SERVICE INFO

Assembly instructions for LuK RepSet® 624 3200 09 and 624 3200 34

Manufacturer: Renault

LuK RepSet®: 624 3200 09
624 3200 34

Image 1: Clutch disc with plastic ring

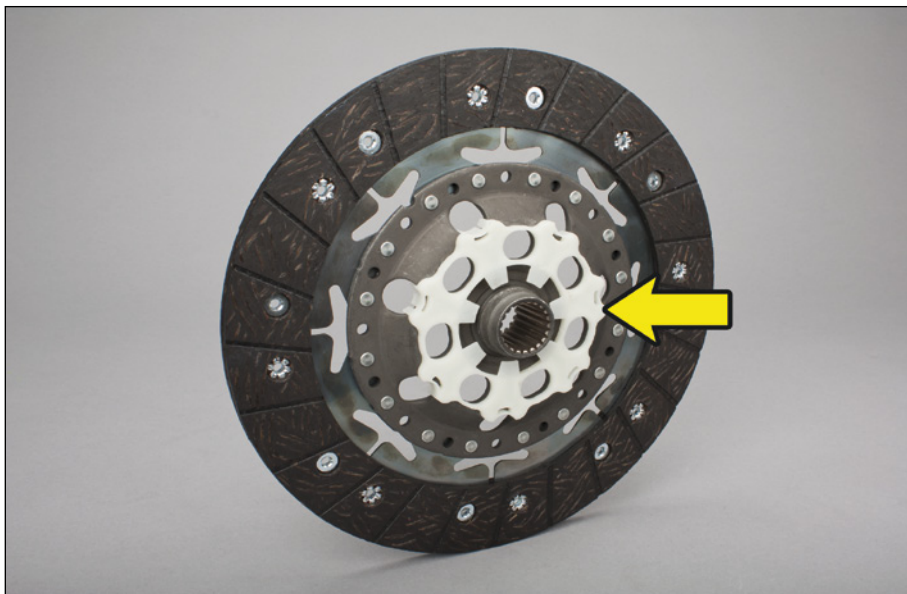
Clutch discs without a plastic ring were generally included in previous LuK RepSets®. Depending on the frequency of repair, either clutch disc version may therefore be installed in the vehicle.

Schaeffler Automotive Aftermarket now only includes clutch discs with a plastic ring in LuK RepSets®.

The plastic ring has no influence on the function of the clutch!
It can be left installed or can equally be removed!
